Description of Revisions: *This bulletin replaces the version dated October 2015. The related VMRS codes are added.*

General Information

Fig. 1, Retaining Pin

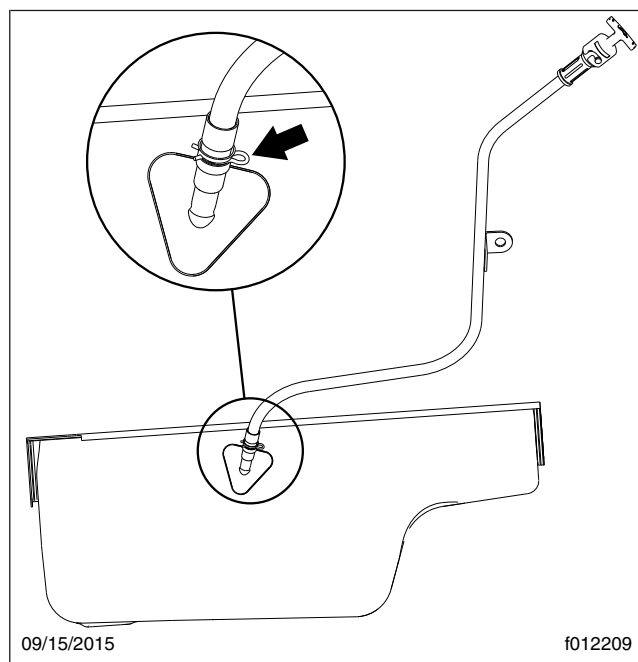
Some Saf-T-Liner C2 chassis built from June 25, 2014 to August 27, 2014 may not have been equipped with a dipstick tube retaining pin during production. This can cause the dipstick tube to rise up and leak oil. Also, the engine oil dipstick may not go to the bottom of the tube, resulting in a false reading. See [Table 1](#) for a list of vehicles.

1. Park the vehicle on a level surface, shut down the engine, and set the parking brake. Chock the tires.
2. Inspect the dipstick tube and oil pan nipple connection for the retaining pin. See [Fig. 1](#).

- 2.1 If the retaining pin is present, no further work is needed.
- 2.2 If the retaining pin is missing, proceed with the next step.
3. Make certain the dipstick tube is seated in the oil pan nipple and the dipstick is fully inserted.
4. Install the retaining pin (23-14023-000). See [Fig. 1](#) and refer to drawing D01-33694.
